SUBJECT: CORRECTION TO TECHNICAL SERVICE BULLETIN 184-014**AFFECTS:** ST-160, ST-180 STRING TRIMMERS

SUBJECT: 1) Starter Rope A-49137
2) Parts List (17435-A) Correction

SUBJECT: 1) PHELON ROTOR 95218-AS FOR WICO IGNITION
2) CORRECTION TO PARTS LIST 17505 REV. 3

SUBJECT: 1) PHELON IGNITION MODULES WITH EXTERNAL GROUND LEAD WIRE
2) CORRECTION TO TECHNICAL SERVICE BULLETIN 185-002 (1/85)

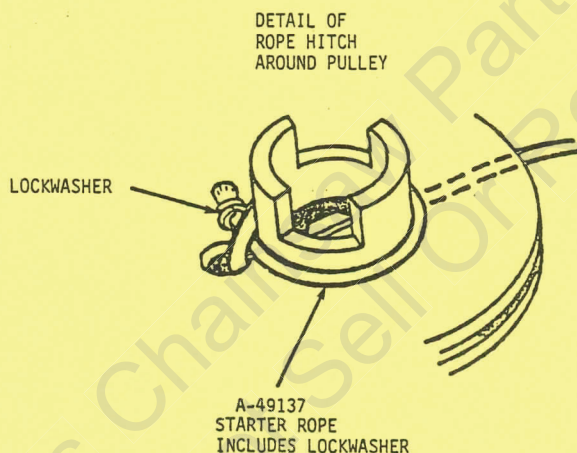
On Technical Service Bulletin 184-014, the illustration of assembly shows the wrong sequence. Please follow the revised illustration below when assembling the shield (94409) and second flat washer (84099).

Use shaft holder tool (94482) to aid in the removal and installation of the drive connector and jam nut. Turn the drive connector and jam nut clockwise (left hand thread) to remove.

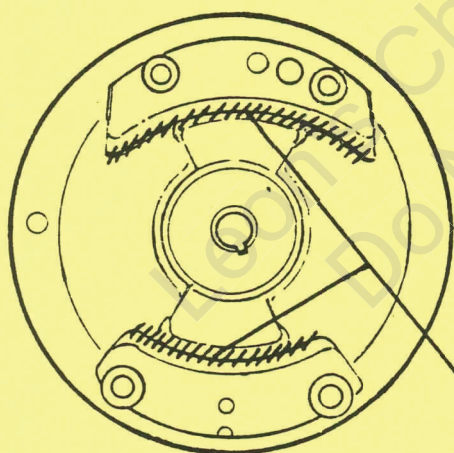
- 1) Starter rope p/n 97500 used in the Model 410 chain saw has been superseded to p/n A-49137 which is also used on the Model DM-40 multi-purpose saw. This starter rope (A-49137) incorporates a lockwasher (83060) crimped onto the pulley end to keep the THROAT SEIZING HITCH from slipping. Refer to the diagram below when installing starter rope on the subject model saws, noting the location of the lockwasher.

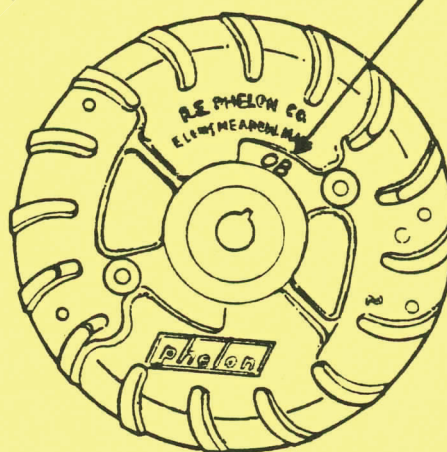
When using this Phelon rotor (95218-AS) on the Wico breaker point ignition system, it may be necessary to file off any excess flashing on the underside of the rotor (see diagram) to prevent possible interference with the point box cover. The breaker box and cover should be inspected for warpage and replaced as needed.

If necessary,
file off excess
flashing in these
two areas

Letter "B"
location

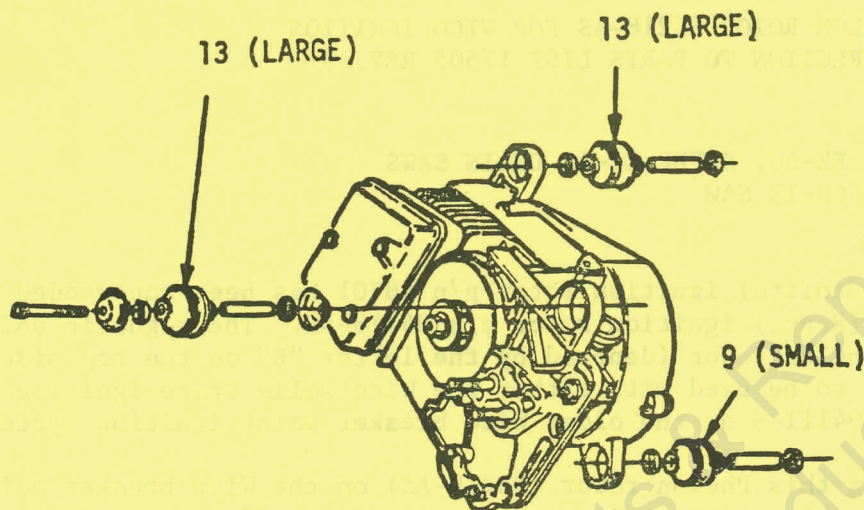
- 2) The isolator item numbers shown in the model 330 parts list (Figure 2) are incorrect. Adjust your parts list according to the illustration below.

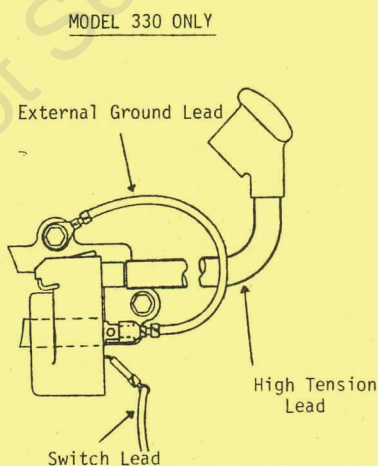
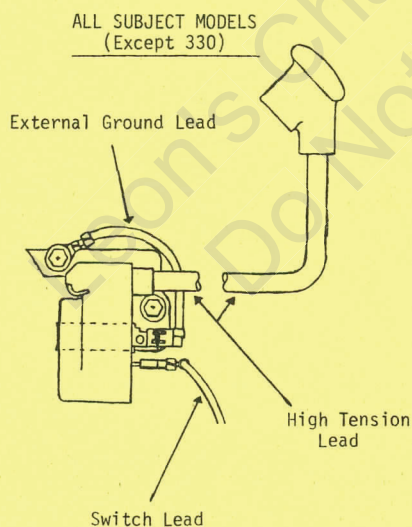
- 1) Phelon ignition modules with the ground tab welded to the core are being superseded by ignition modules with an external ground lead wire. During assembly on the subject models (except the model 330 chain saw) this ground wire should be routed under the high tension lead and installed under the head of the top module mounting screw (see Figure 1). For the model 330 only, route the ground wire over the high tension lead (see Figure 2).

**CARBURETOR
(WS-22) Walbro
A-97102**

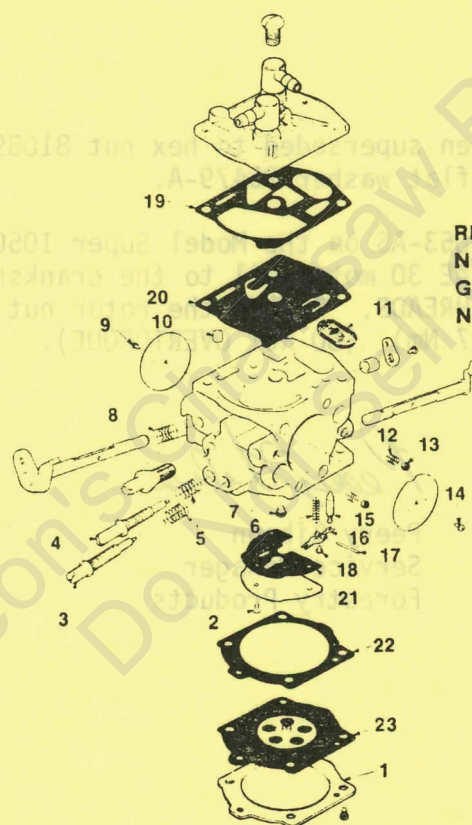
- 1) 410 chain saws(beginning with Lot # E074) were manufactured with carburetor A-97102 (Walbro WS-22). This carburetor (also used on the DM-40 saw) incorporates an internal air bleed circuit for improved idling and acceleration. Refer to the illustration below when ordering repair parts for this carburetor.

REPAIR KIT (1-23)	97132
NOZZLE CHECK VALVE (7)	97131
GASKET/DIAPHRAGM KIT (19-23)	97133
NEEDLE- Inlet (15)	64229

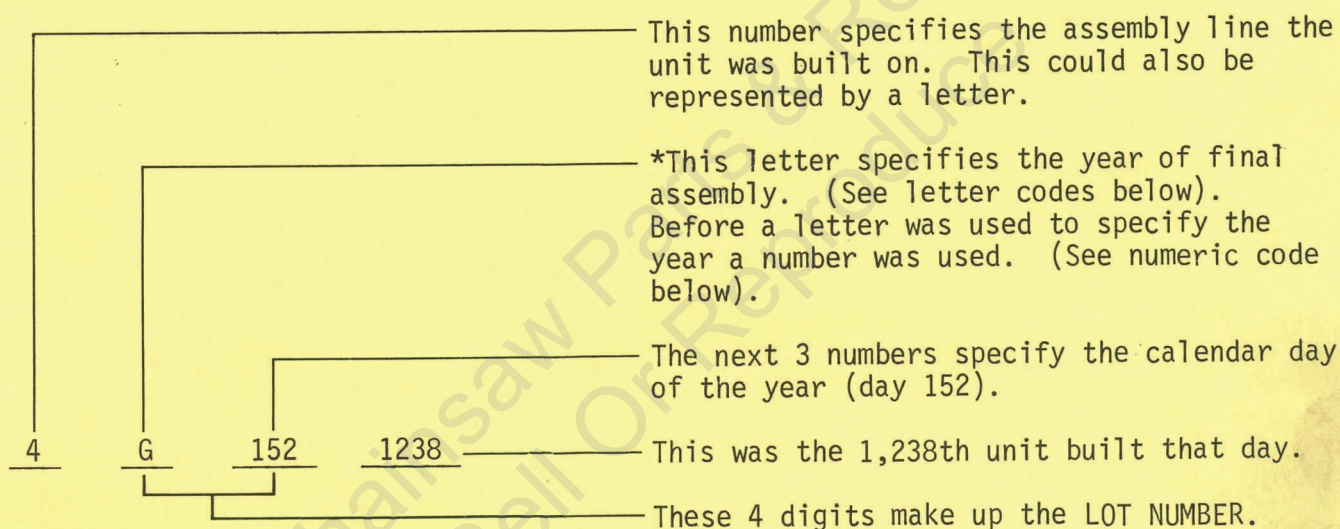
- 3) When assembling the bumper spike to the Model 410 chain saw, the plastic sealing washer should be installed onto the screw between the crankcase and the nut. When the nut is tightened, the plastic washer collapses and fills the pocket in the crankcase for improved spike retention. See diagram.

FIGURE 1

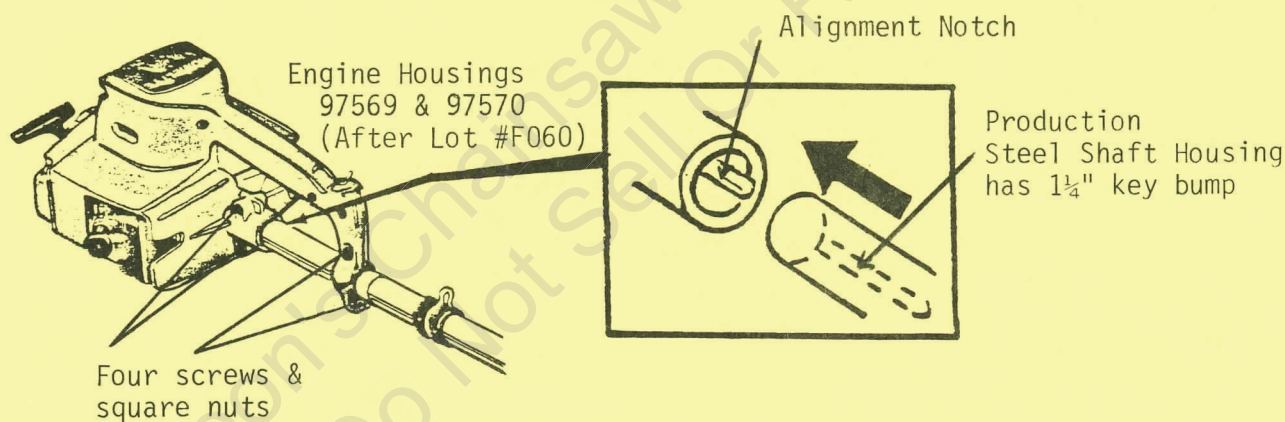
The production steel shaft housing has a $1\frac{1}{4}$ " long key bump at the engine end which aligns with a notch in the engine housing (see Figure 1). This shaft housing, however, will only fit units made after Lot #F060 (1984) which were produced with engine housings 97569 and 97570.

FIGURE 2

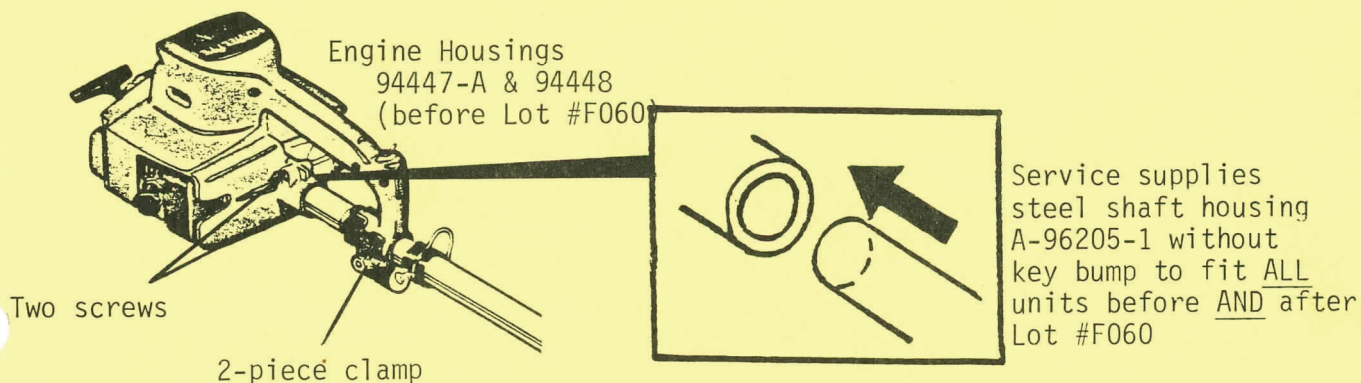
Service parts will supply a steel shaft housing (A-96205-1) without the key bump which will allow it to fit ALL ST-200 and ST-210 units. (see Figure 2)

FIGURE 1

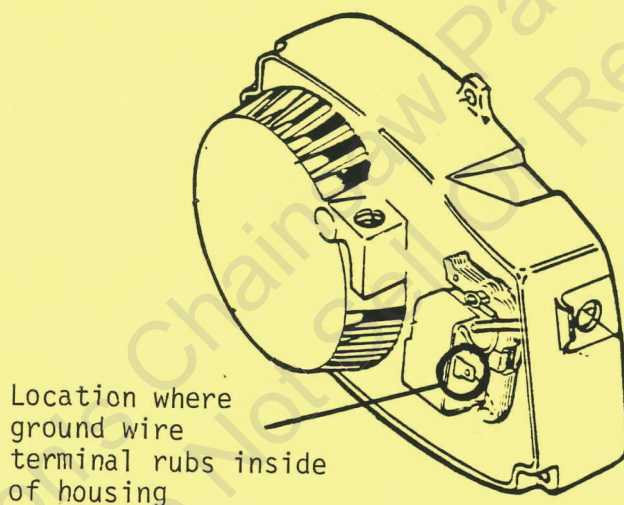
Remove the starter housing and inspect the inside surface for a small area where the paint is rubbed off (see Figure 1). This indicates the ground tab (for the stop switch wire) coming out of the module is angled improperly and is allowing the switch lead wire to rub and ground out against the starter housing.

FIGURE 2

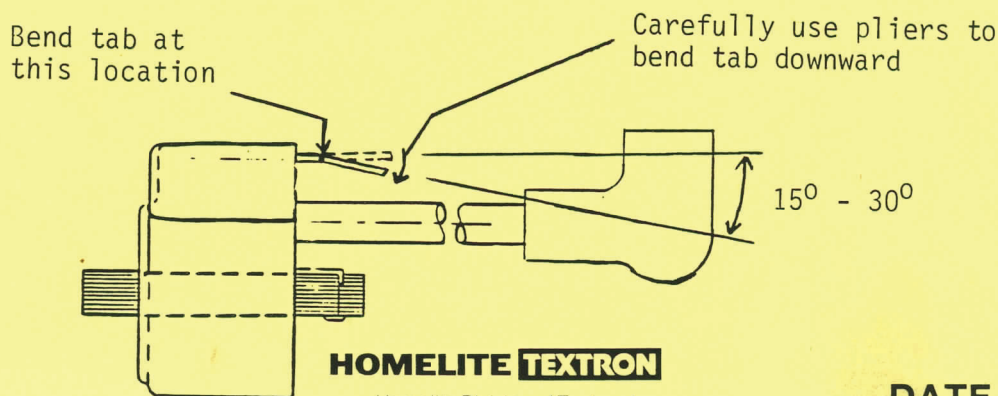
The ground tab can be bent slightly downward by carefully using a pair of pliers (see Figure 2). The tab should be angled between 15° and 30° to prevent the switch lead wire from contacting the starter housing.

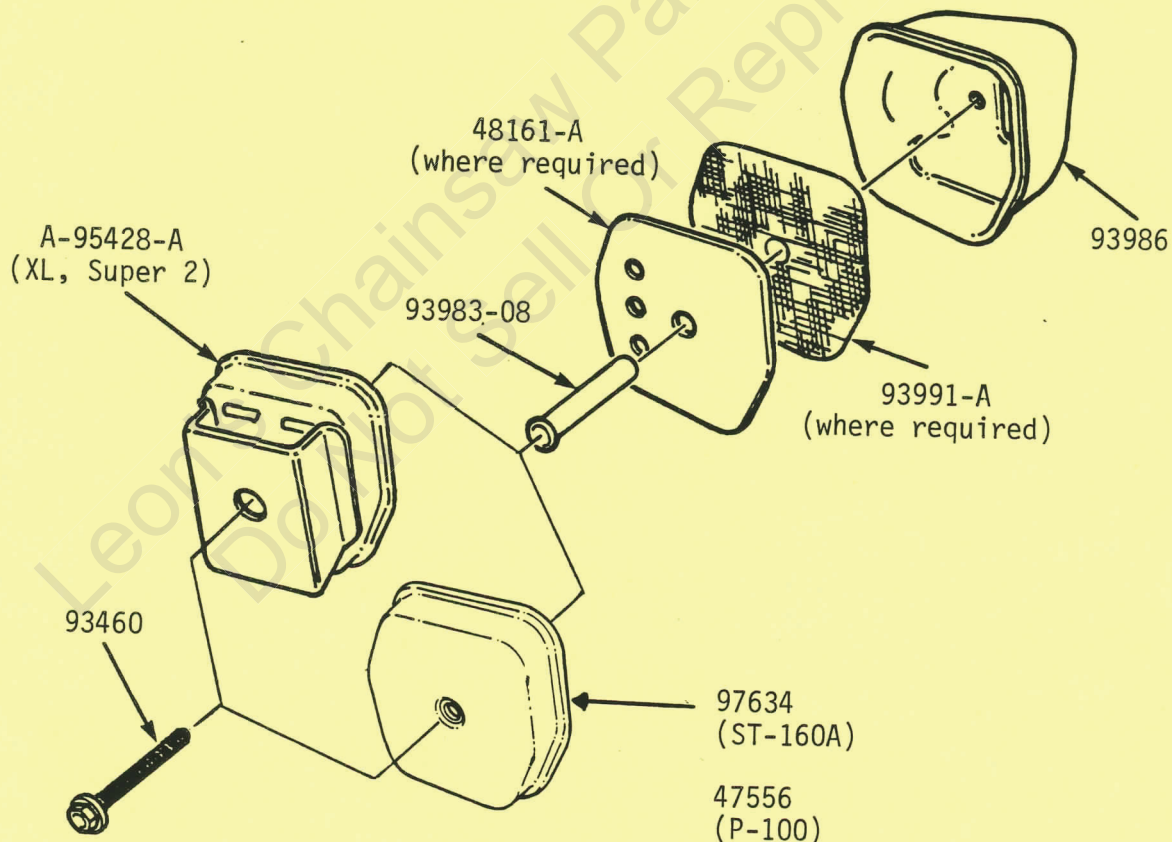
The muffler assemblies have been revised on the subject model units. Both the short and long spacers have been replaced with a single, longer spacer P/N 93983-08. This single spacer required enlarging the center hole in the spark screen (where required) and baffle (where required) to facilitate assembly.

Refer to the illustration below when ordering parts for the revised muffler assemblies.

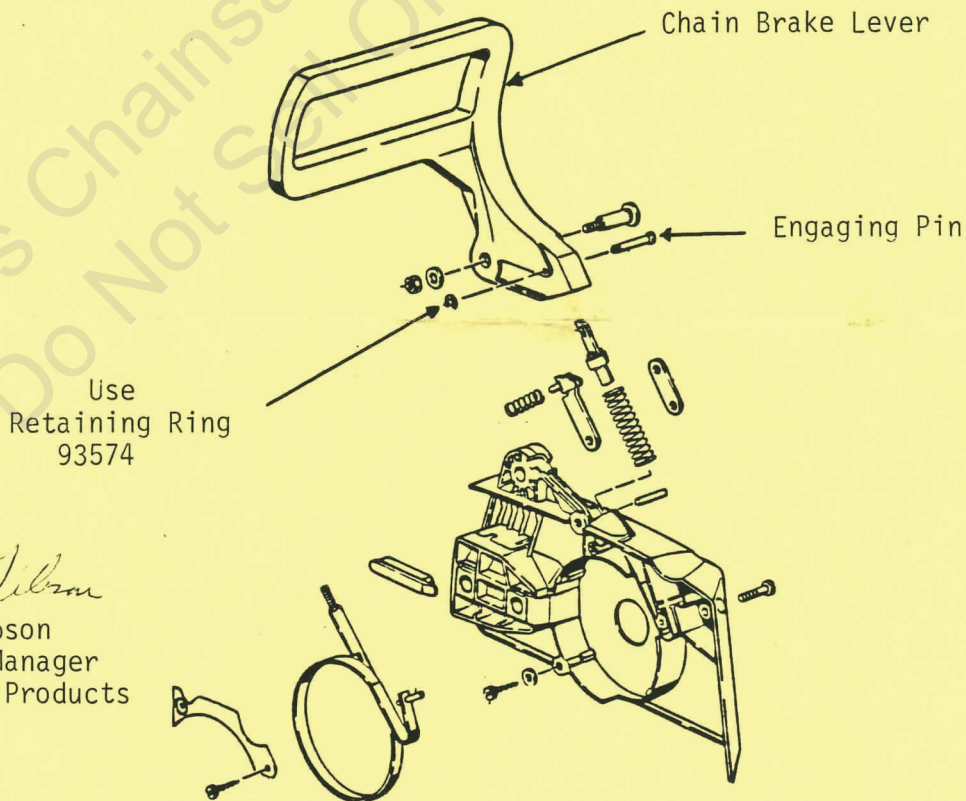
The retaining ring which holds the engaging pin in the chain brake lever should be replaced with P/N 93574 retaining ring (see illustration below) on ALL subject units.

FIGURE 1

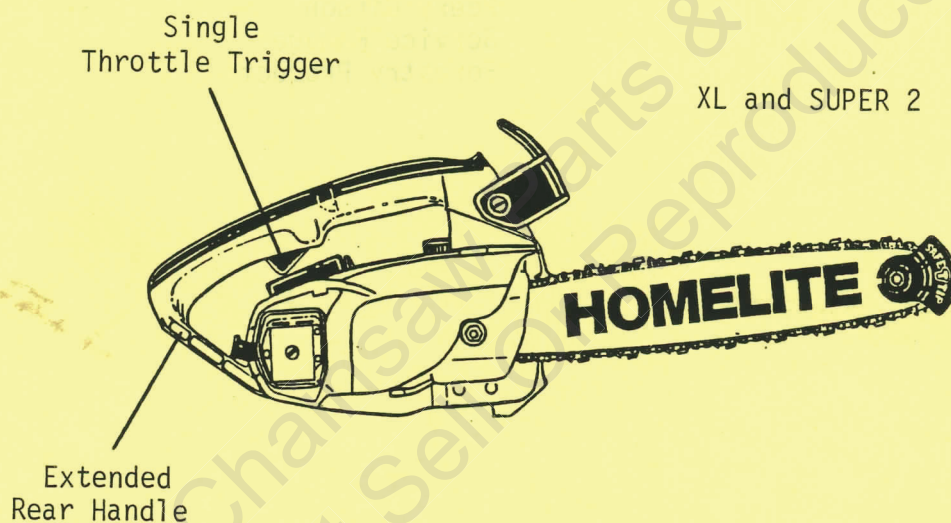
- 1) The models XL and Super 2 chainsaws now utilize the identical nylon engine and starter housings. The engine housing has an extended rear handle with a single throttle trigger (see figure 1).

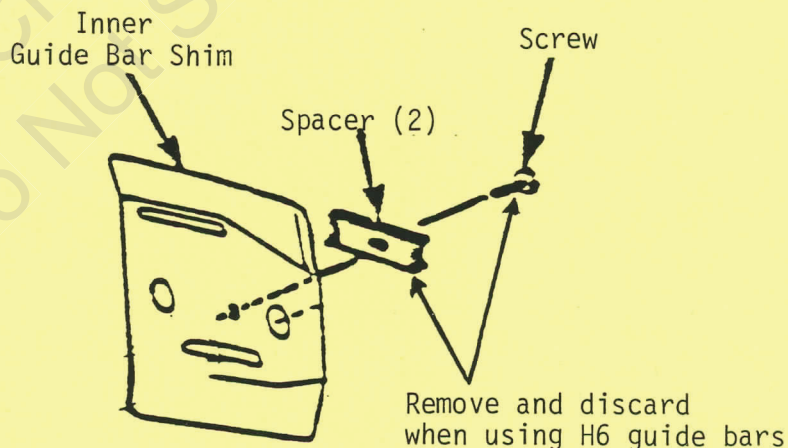
When replacing the G5 series guide bar with an H6 series guide bar, the two spacer plates and retaining screw (80513) MUST be removed and discarded (see diagram below).

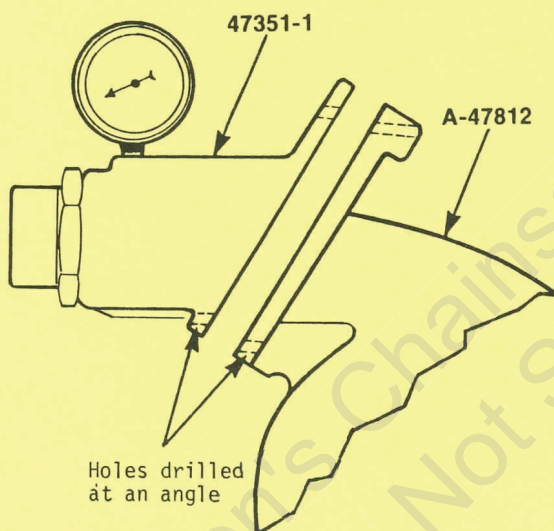
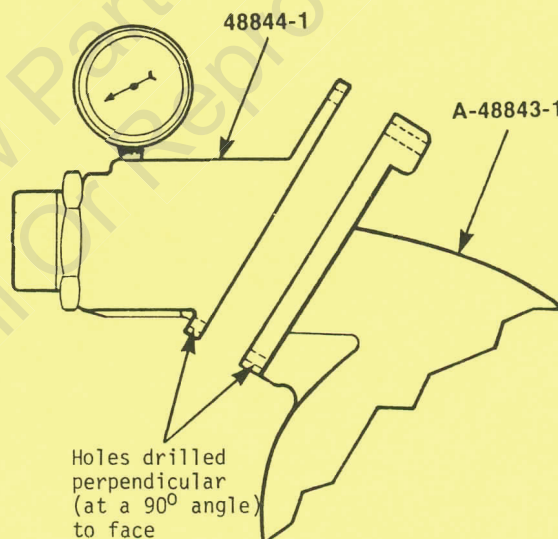
A new pump and valve body are now being used on the FP250. The bolt holes in the new design are drilled perpendicular (at a 90° angle) to the face where the flapper valve seats. This aids in assembly and prevents the flapper valve from moving when the valve body is assembled and torqued. Both old and new style parts are available.

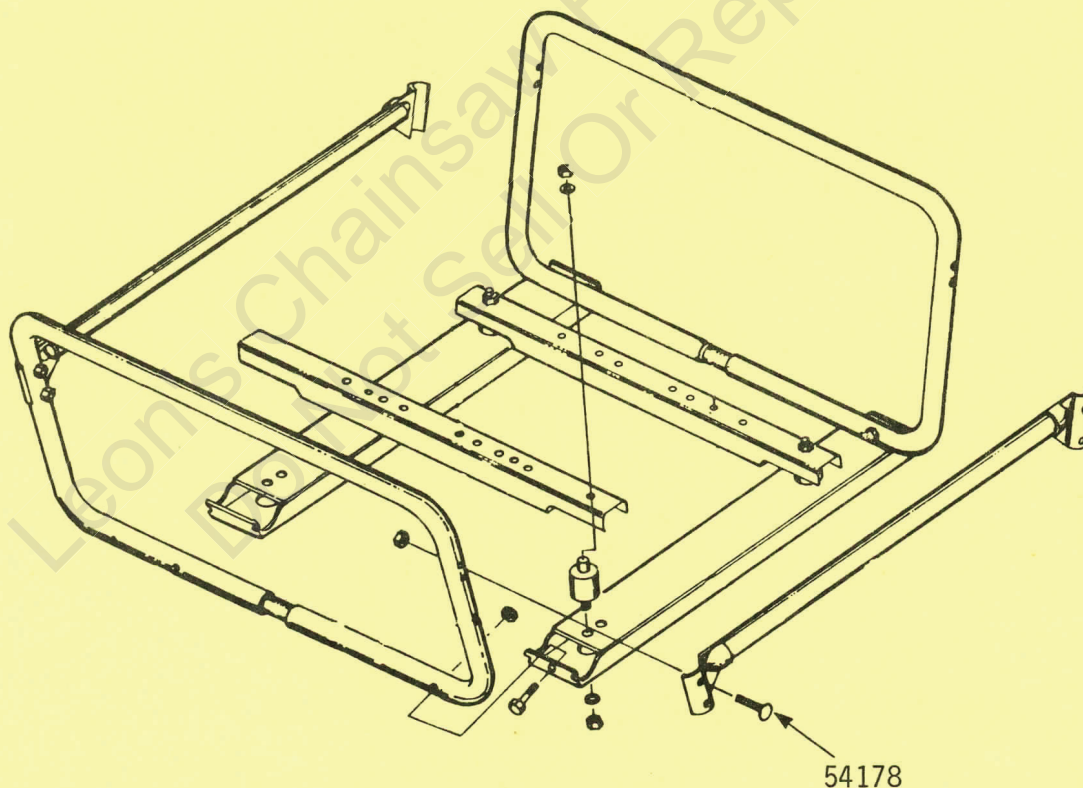
A new curved head screw will be used on the carrying handles for the above generators. The new screw part number 54178 is 1½ inch long. The extra ¼ of an inch will aid in assembly.
